**Re: Seacoast Reliability Project - SEC Docket 2015-04
Notification of Minor Construction-Related Changes
Submarine cable and Eastern Shore Landing**

LIST OF FIGURES

Newington Cable Landing and Slope Restoration

SEACOAST RELIABILITY PROJECT
 LITTLE BAY, NH
 NEWINGTON CABLE LANDING AND
 SLOPE RESTORATION, X-SECTIONS

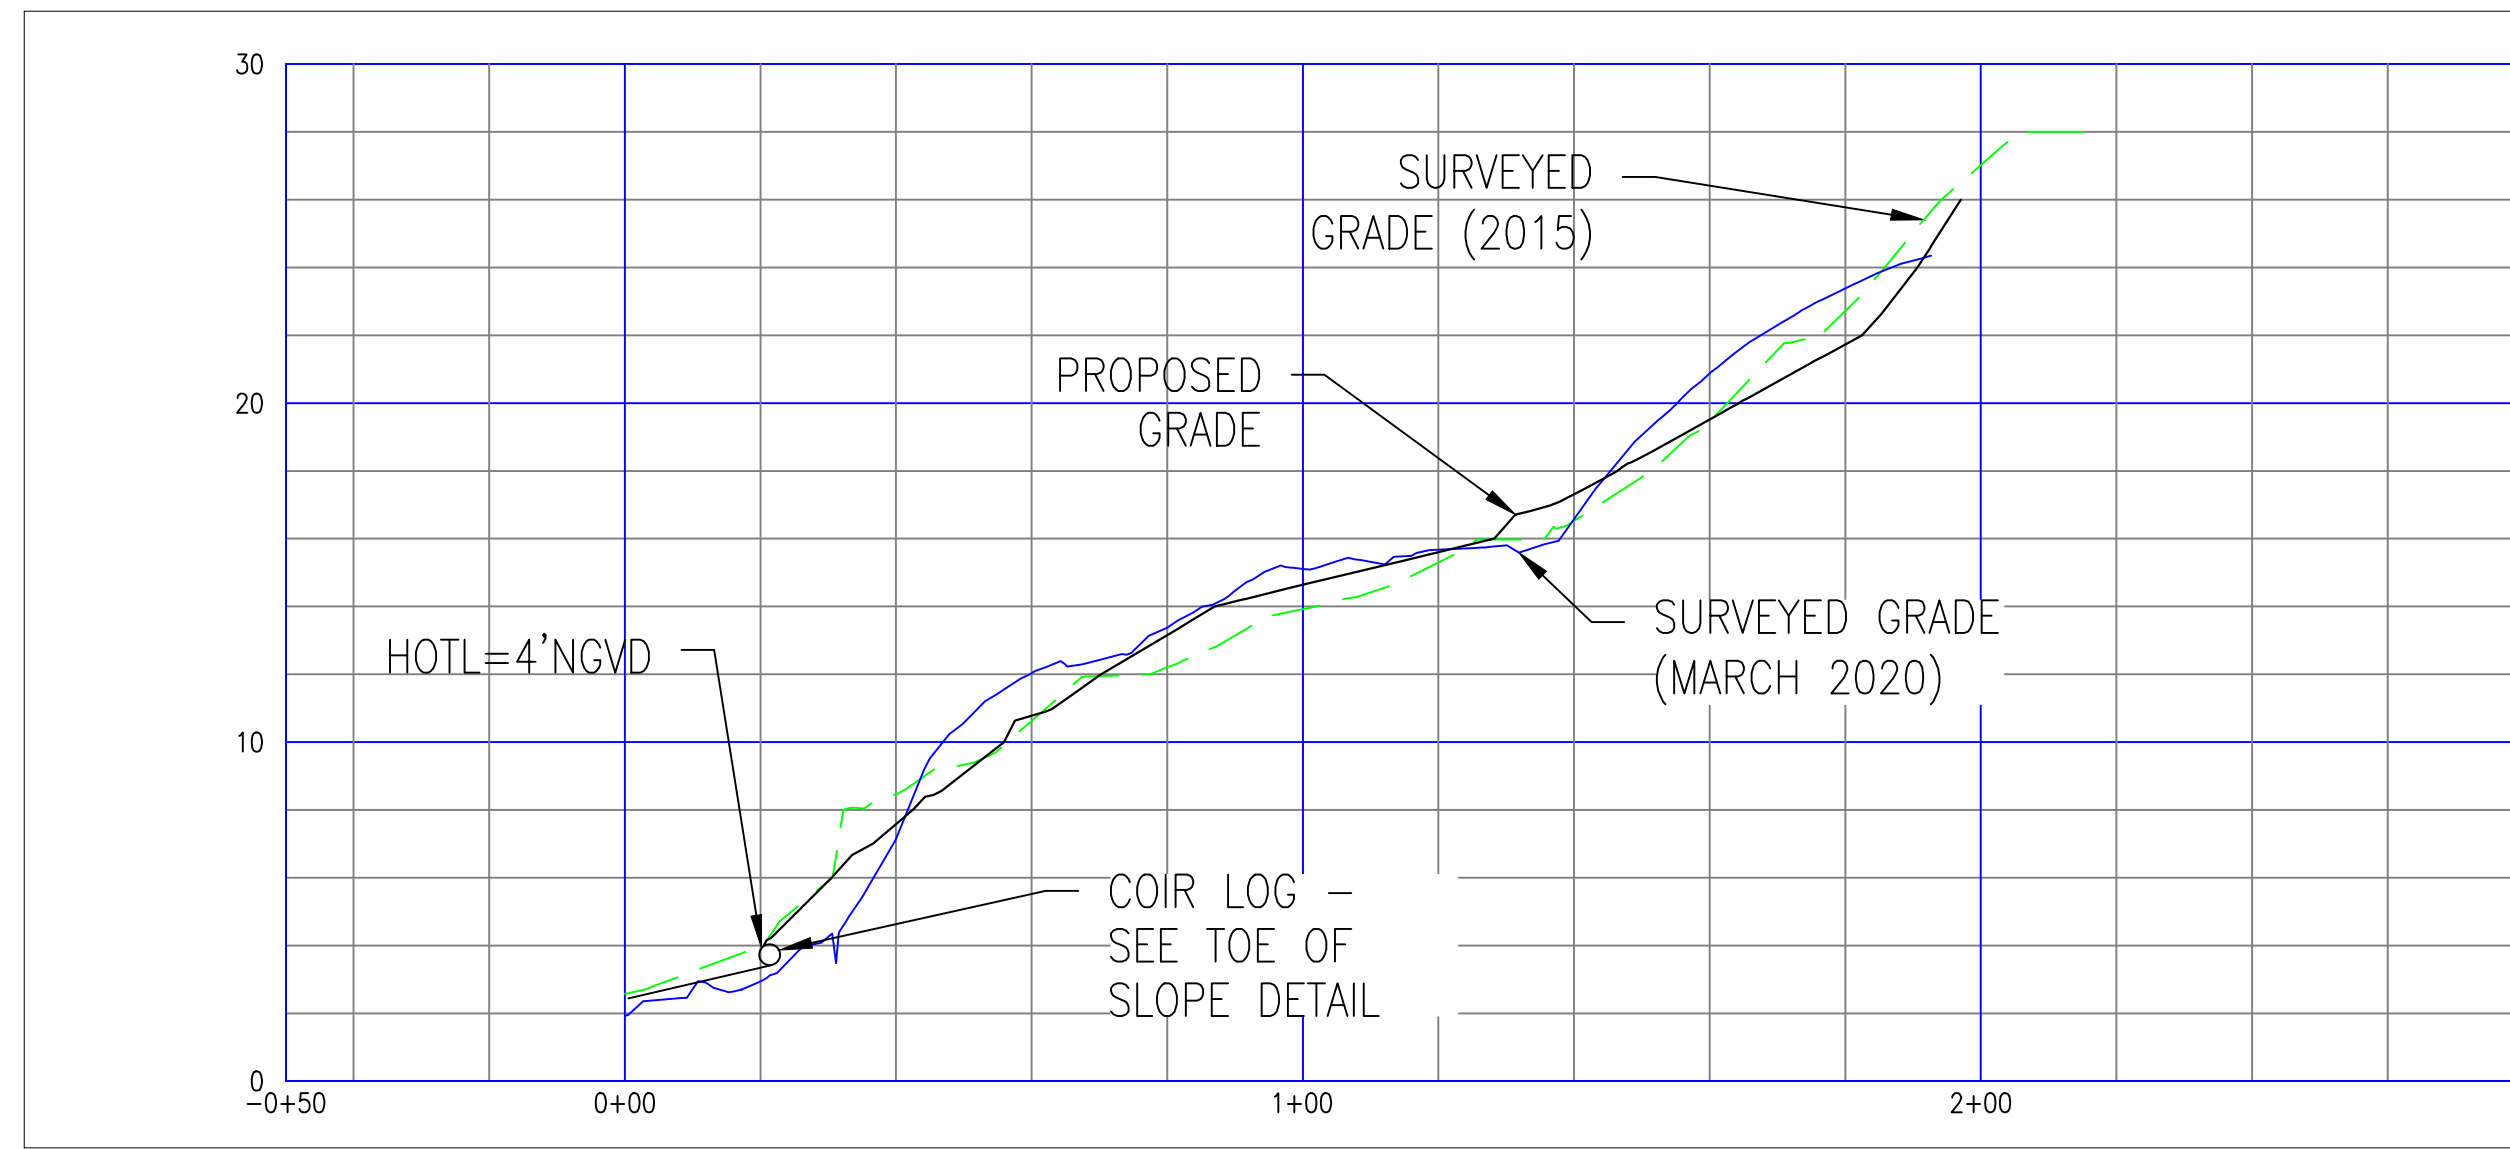
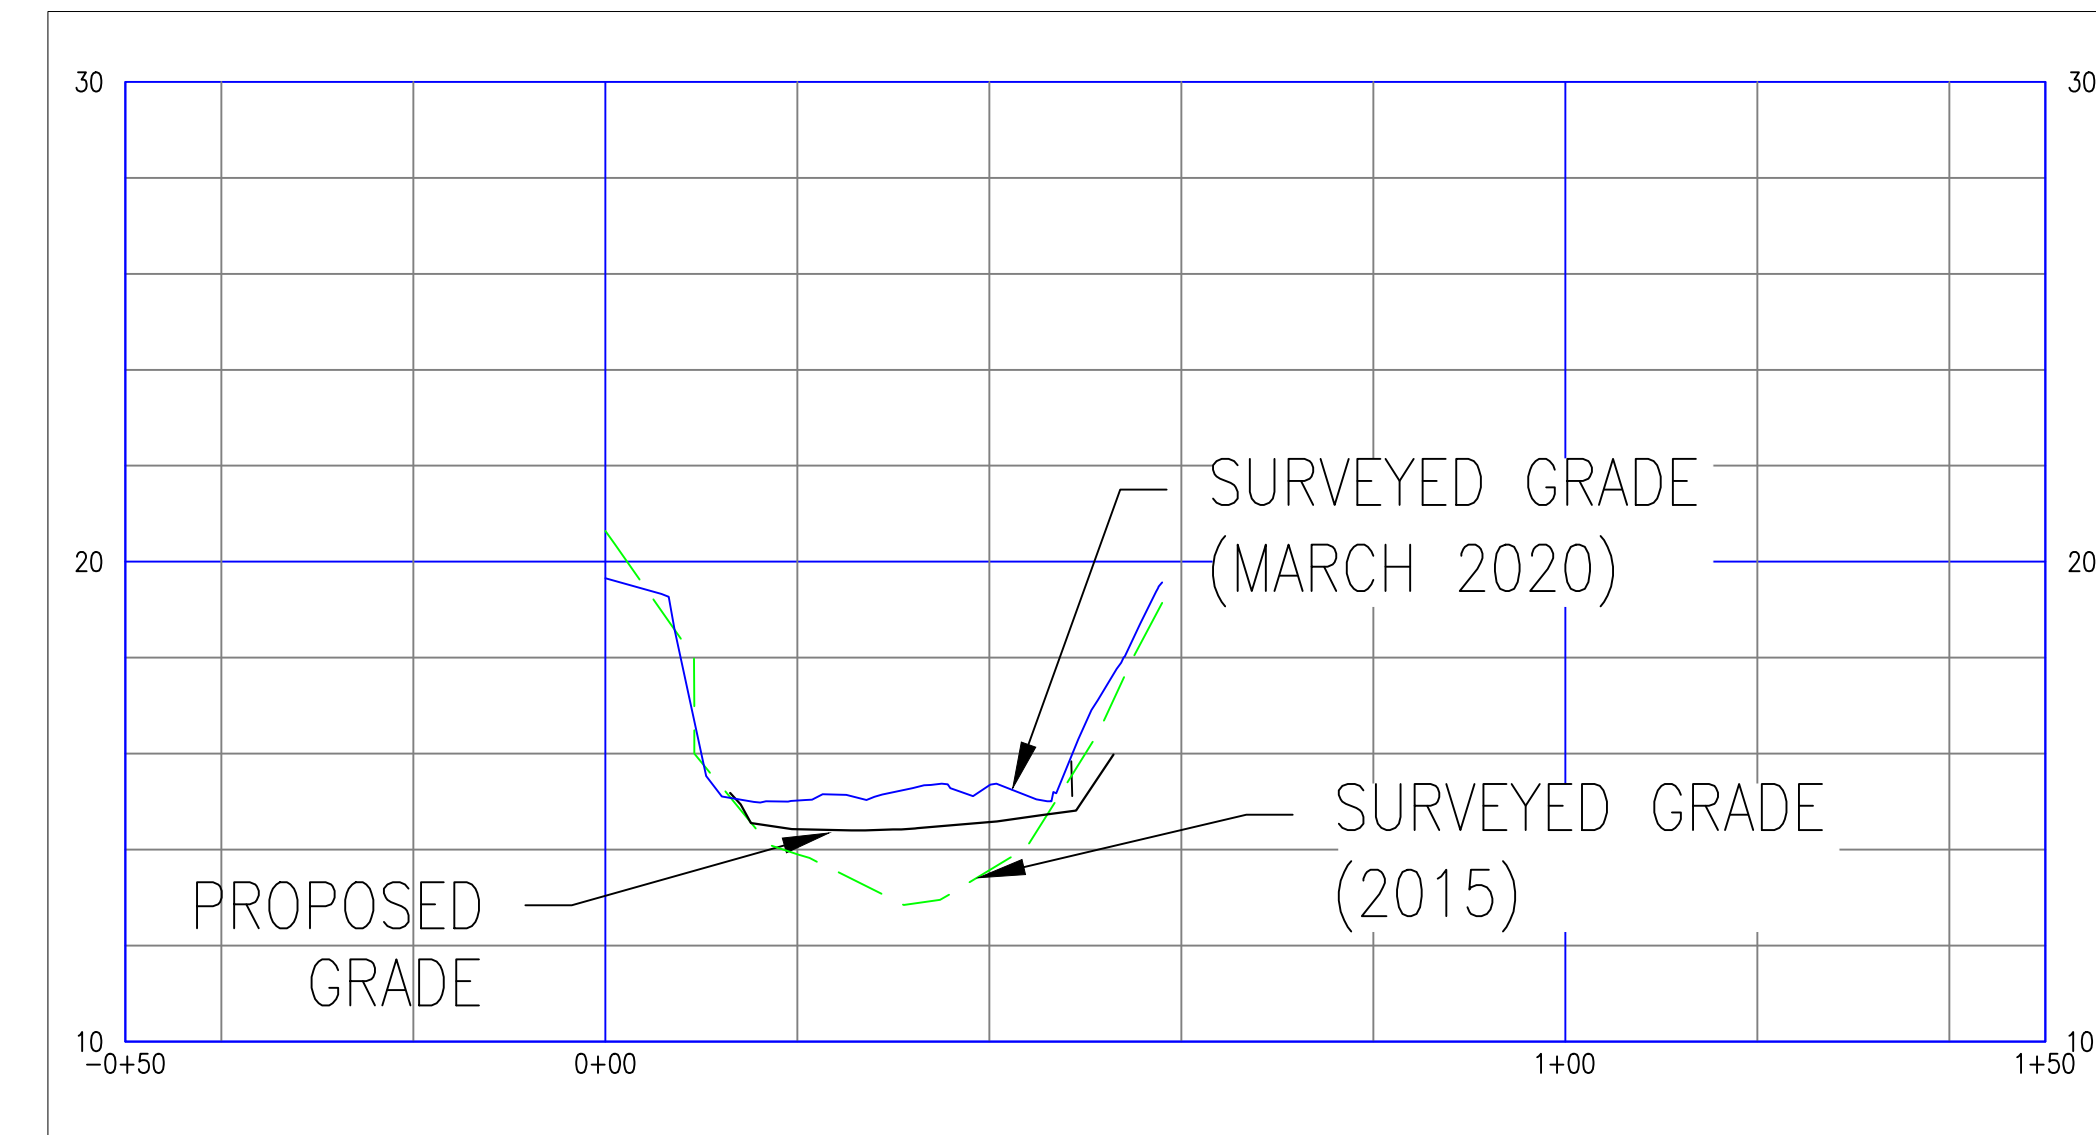
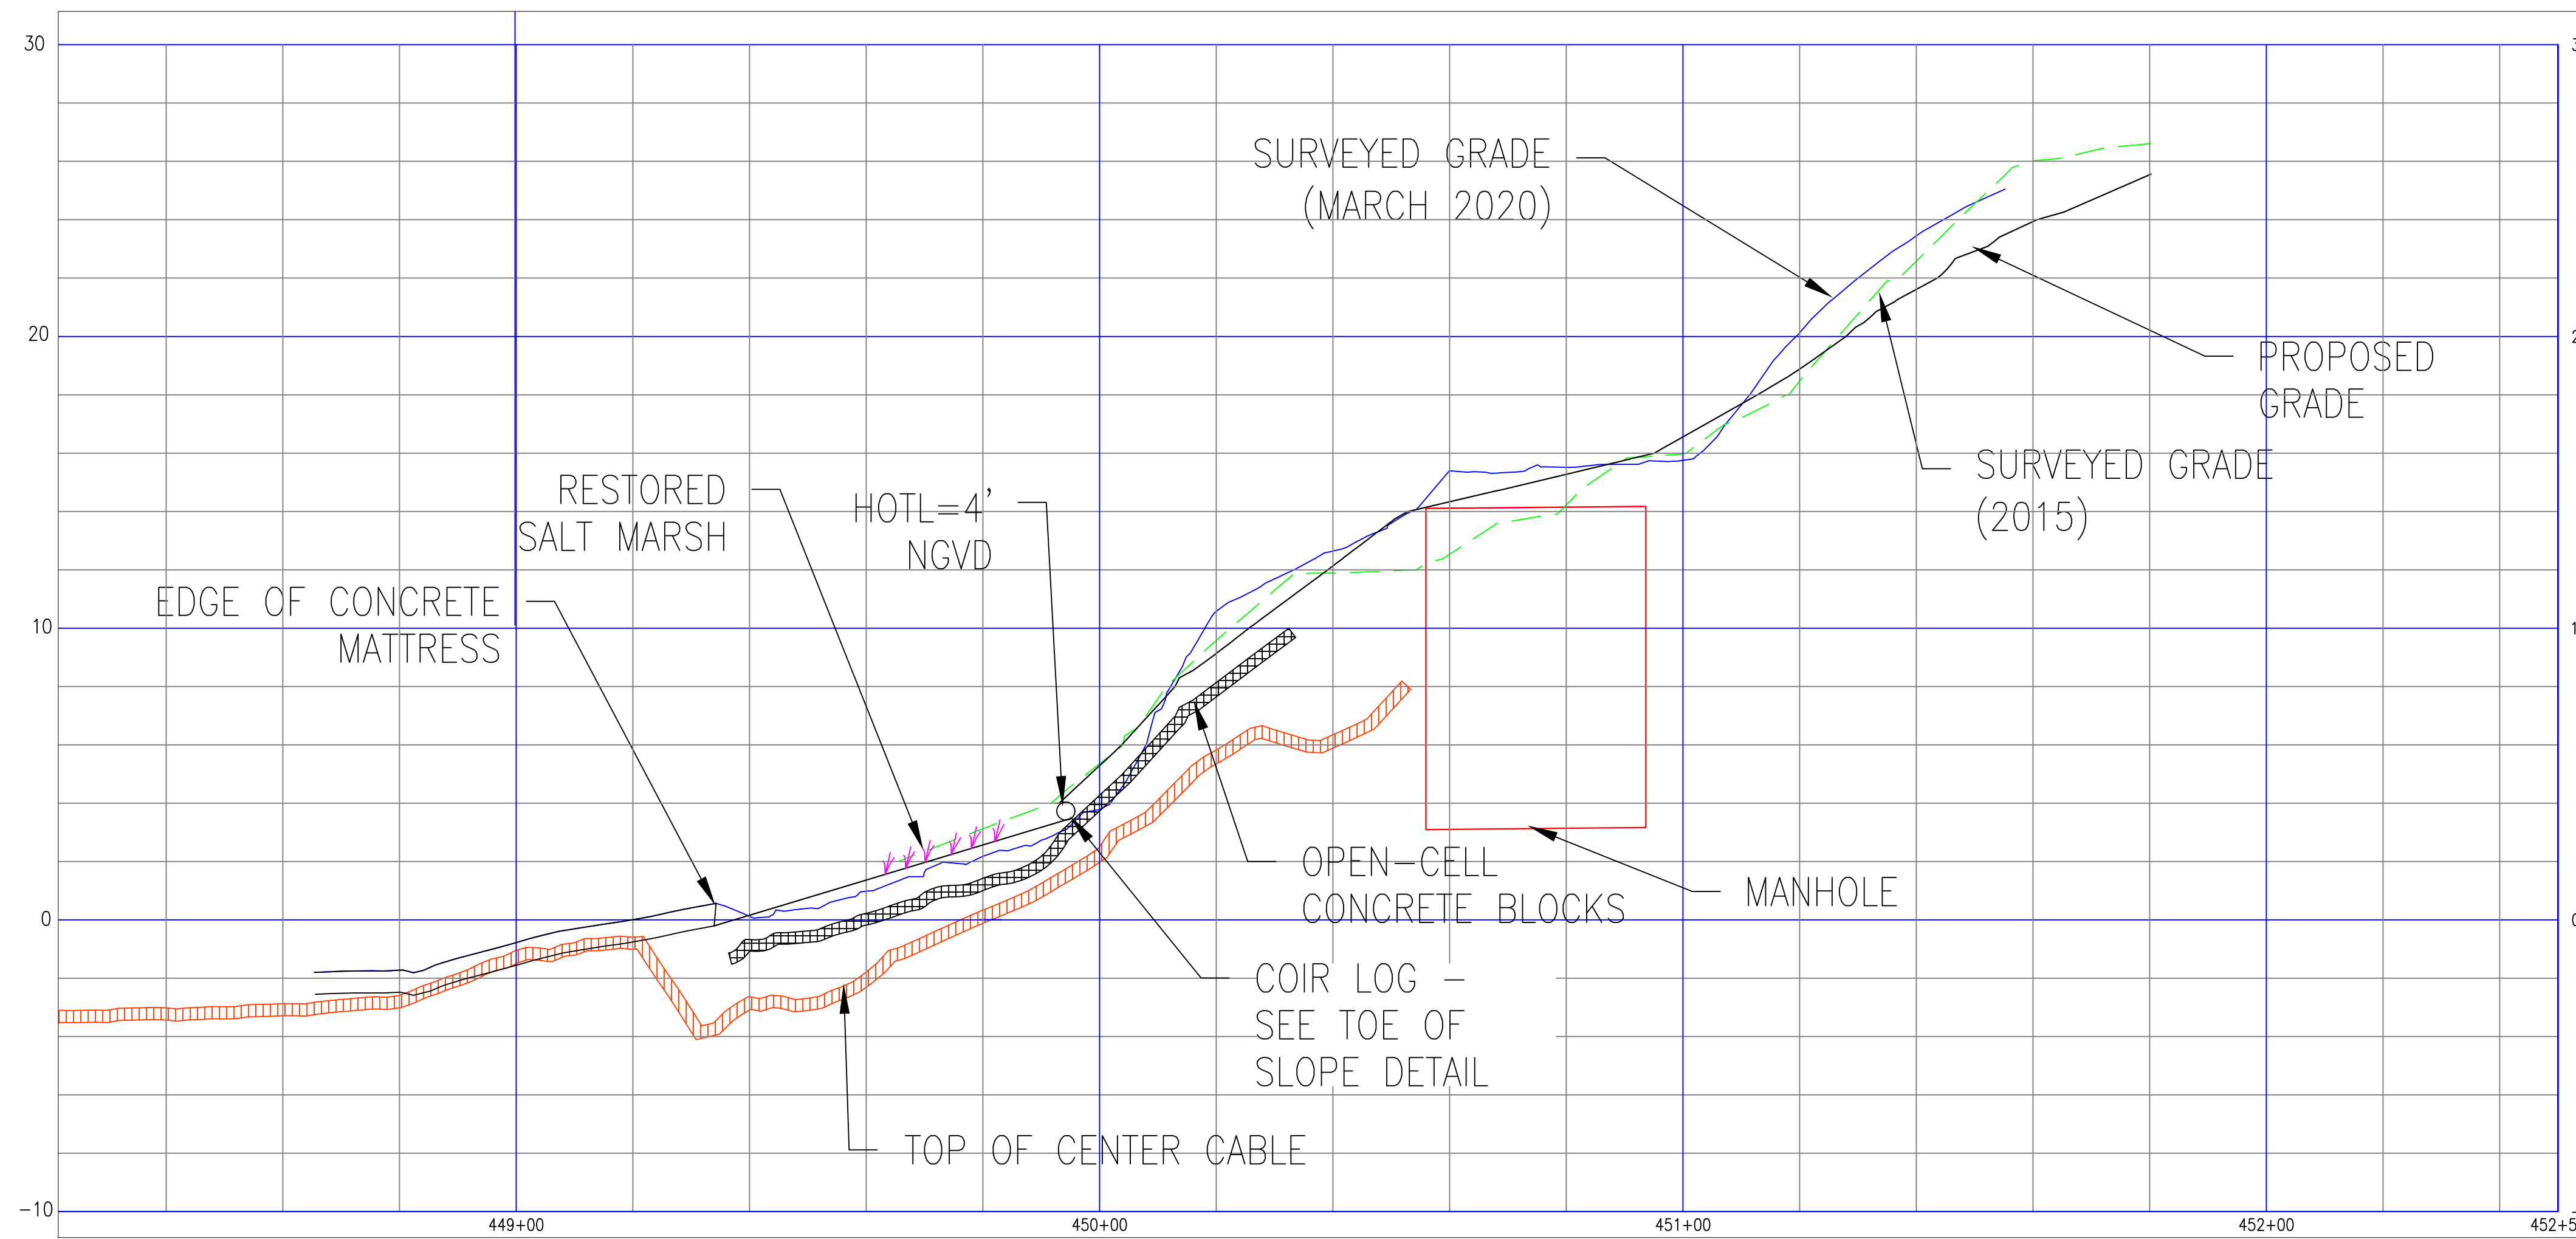
Final grades on the property will be controlled by the elevation of the manhole, the toe of slope and the amount of cover or supplemental protection that is required to protect the cables. Stormwater management is also a consideration, due to the sheet flow that drains to the area from the lawn above, and several drains from the driveway that discharge on the north side. The grades shown on Sheet 1 of the *Newington Cable Landing and Slope Restoration* plan set address those concerns and match the original 2015 grades in most locations.

The gravel path will be approximately 8' wide and consist of 6-12" of gravel over the subsoil. The existing drain pipes that discharge to the area will remain in place, but shortened or extended as needed to match final grades. The ones that discharge on a steep side slope will have the same coarse gravel finish as is currently in place.
